Date Issued :	June 21, 2022	PCN Number :	512072
Reason for Change :	Change Supplier		
Description of Change :	This notification is to inform you about change of supplier impacting the part(s) attached as per list, No changes will be made to product as part of this change		
Reason for Short Notice :	Special Request		
Assessment of Change :	Reliability Test Report/s		
Planned Implementation Date :	September 30, 2022		
Sample Availability Date:	September 25, 2022		
Internal Molex Qualification Date :	September 25, 2022		
Last date to request Samples by Customer :	September 30, 2022		
Traceability Code Markings / Date :	Date code

Product Series: 47306xxxx

Metal Post series: 67800xxxx

Add post alternative copper materials
"HBI59"

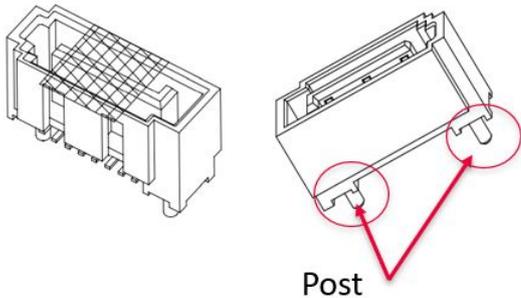
Before	After
1. MATERIAL: LOW LEAD BRASS C6802.	1. MATERIAL: a. LOW LEAD BRASS C6802 b. LOW LEAD BRASS HBI59. (F2)
